ADDENDUM # 2 *Dated: August 6, 2015*

**PRE-K-8 SCHOOL AT MOLLY OCKETT
MSAD # 72, FRYEBURG SCHOOL DISTRICT
FRYEBURG MAINE
BUILDING CONTRACT**

STEPHEN BLATT ARCHITECTS
P.O. BOX 583
5 SOUTH STREET
PORTLAND, MAINE 04101-0583
207-761-5911
Attn: Ron Rioux, email: rjr@sbarchitects.com

26 STAFF S127
A5.6 SCALE: 1/4" = 1'-0"

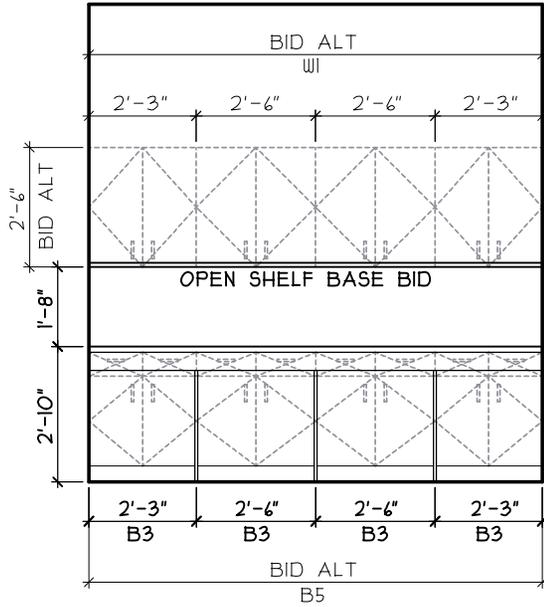
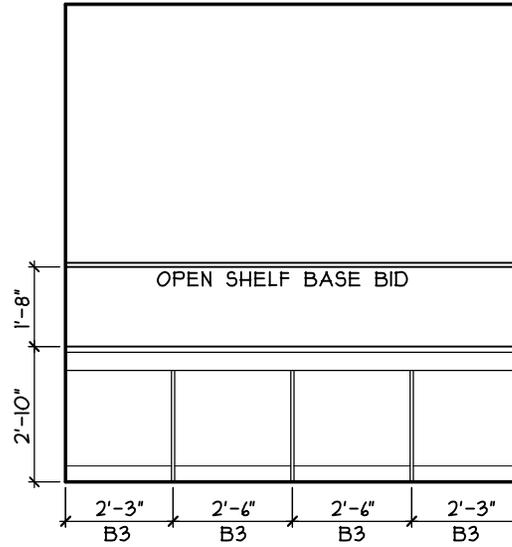
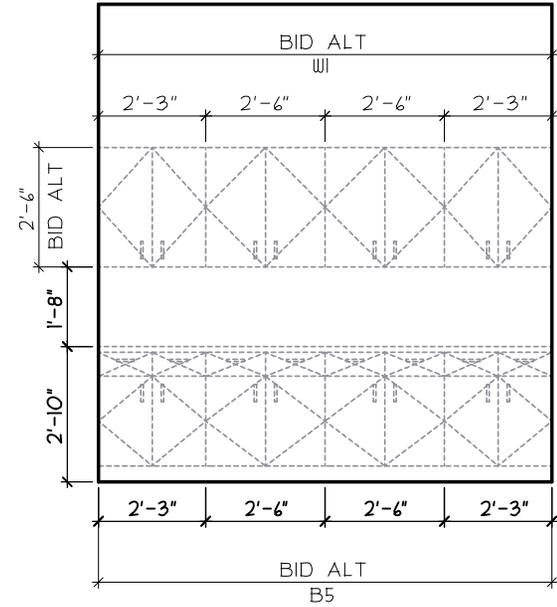
16. Drawing A5.6, Detail 26, See the attached detail provided as an example to clarify the intent of the bid alternate for casework. Refer to drawing A5.01 for typical casework types and assemblies.

AS DRAWN

BASE BID

BID ALT

SKE-2

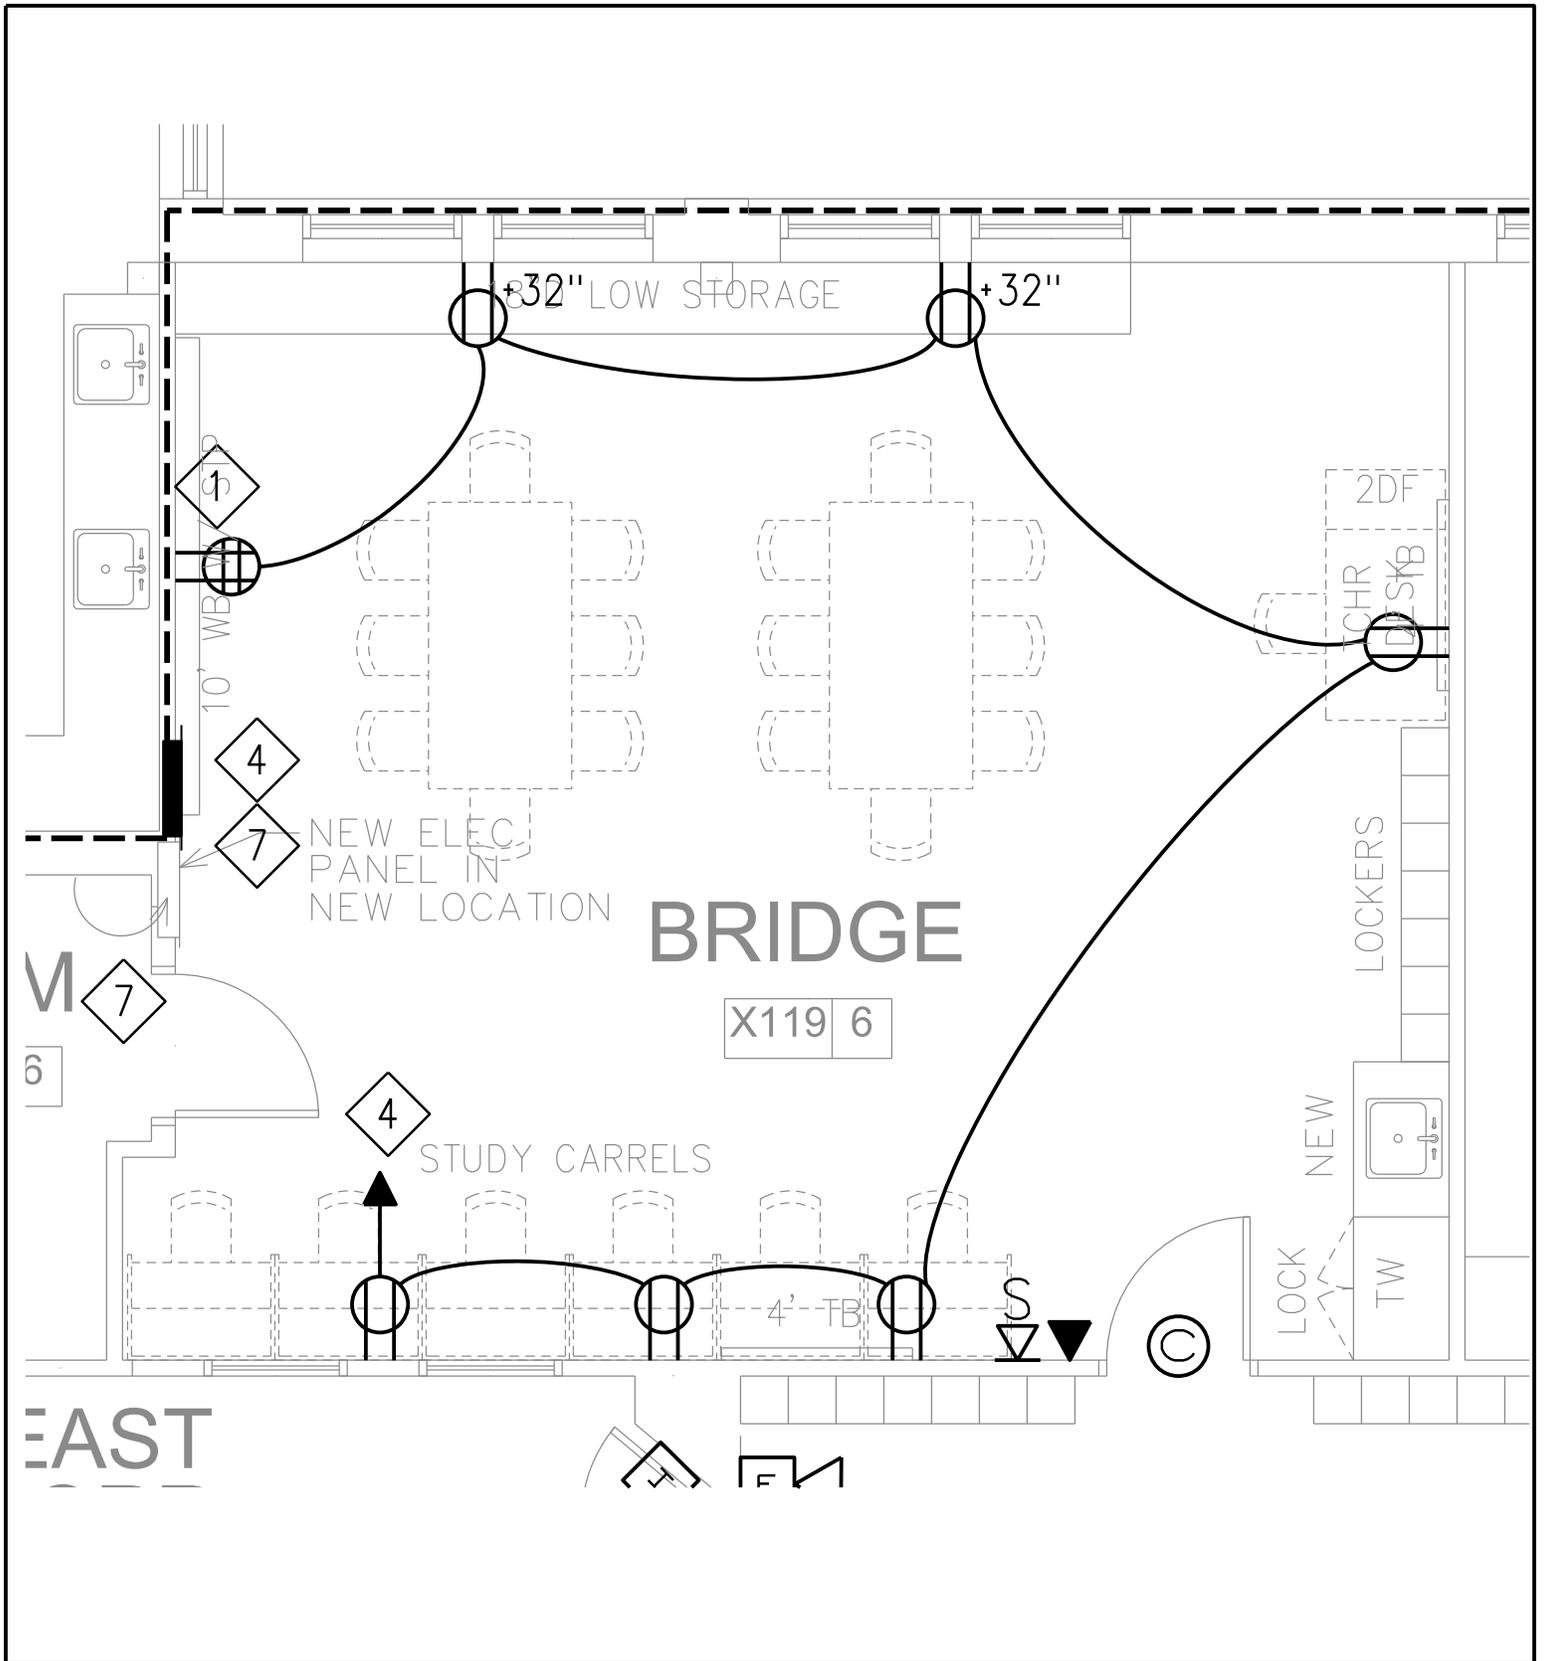
21. Drawing E4.3 Replace duplicated Panel MP on upper left corner of drawing with Panel EP schedule as shown on SKE-2.
22. Drawing E4.3 Panel MM Schedule: change panel rating from 400A to 225A.

REPLACE PANEL MP ON DRAWING E4.3 WITH PANEL EP

SKE-3

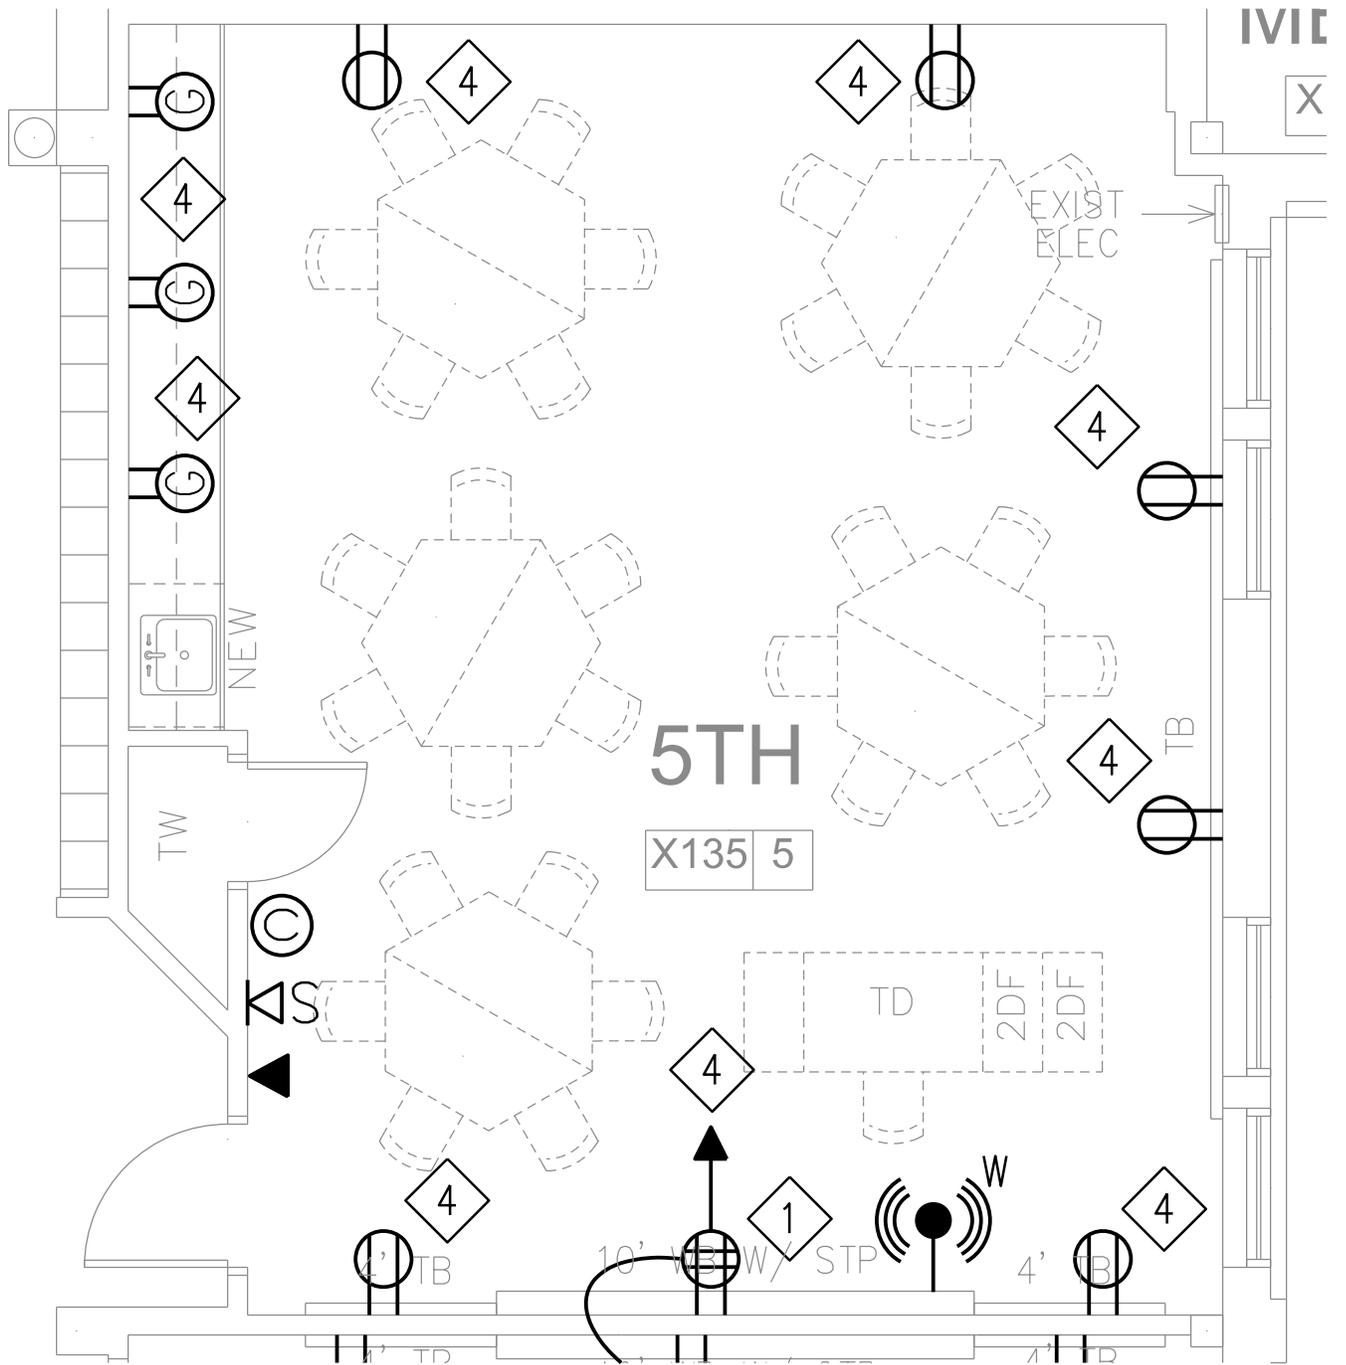
14. Drawing E3.2: Provide receptacles in Room X119 per sketch SKE-3
15. Drawing E3.2: Provide receptacles in Room X134A per sketch SKE-4
16. Drawing E3.2: Provide receptacles in Room X135 per sketch SKE-5

SKE-8

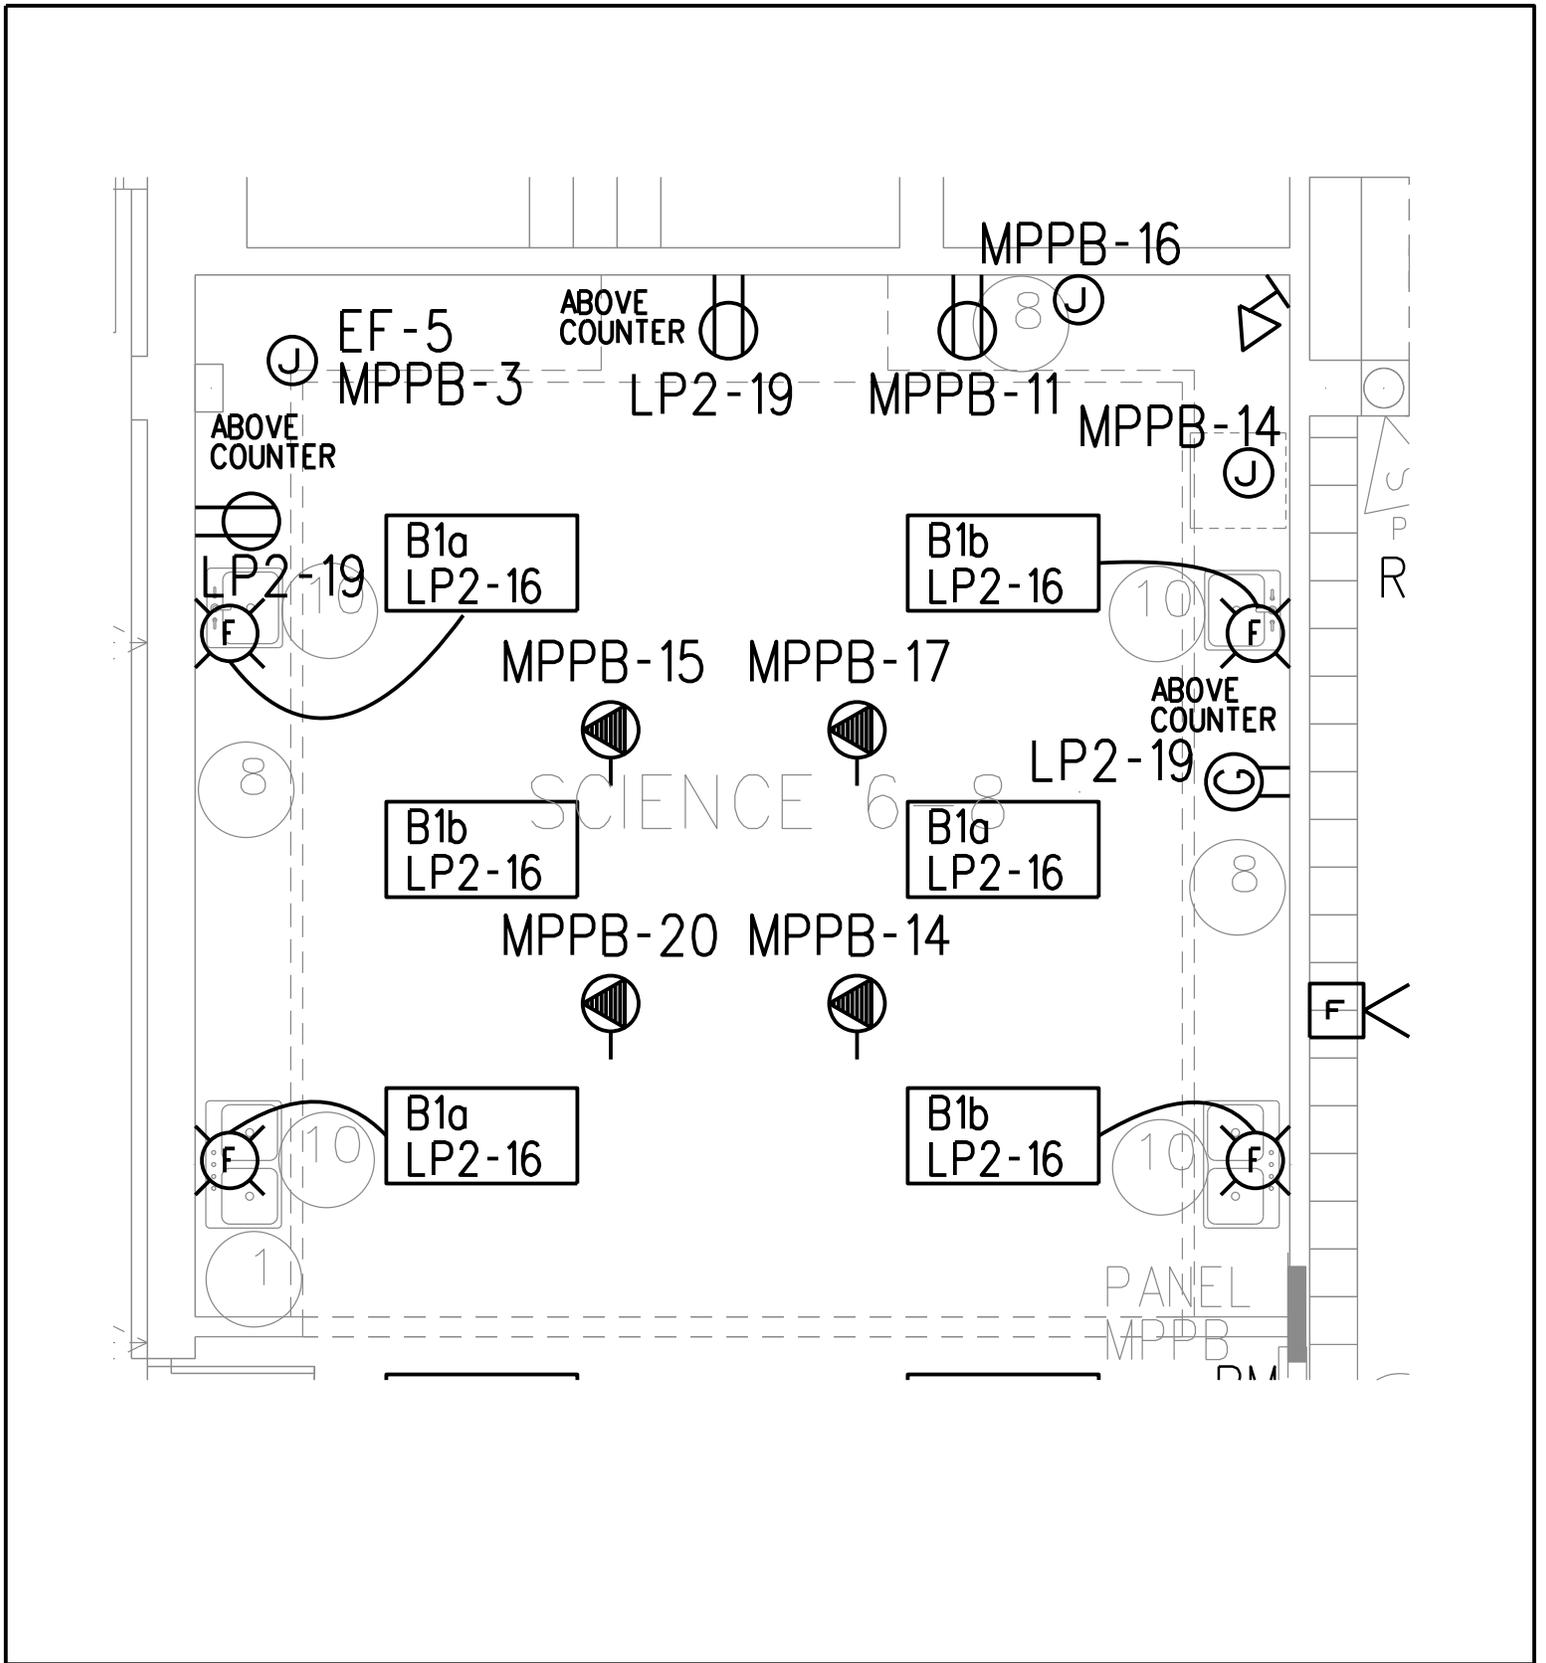
1. Drawing ED1.1: Demolition clarifications per SKE-8
2. Drawing ED1.1: Demolition clarifications per SKE-9
3. Drawing ED1.1: Demolition clarifications per SKE-10
4. Drawing ED1.1: Demolition clarifications per SKE-11
5. Drawing ED1.1: Demolition clarifications per SKE-12
6. Drawing ED1: Demolition clarifications per SKE-13
7. Drawing ED1: Demolition clarifications per SKE-14
8. Drawing E2.1, E2.2, E2.3: Provide one ceiling mounted PIR motion sensor in every classroom and office.
9. Drawing E2.1: lighting fixture Schedule, Type W4, add to remarks-fixtures are being purchased by the site phase electrical contractor and are to be installed by the building phase electrical contractor.
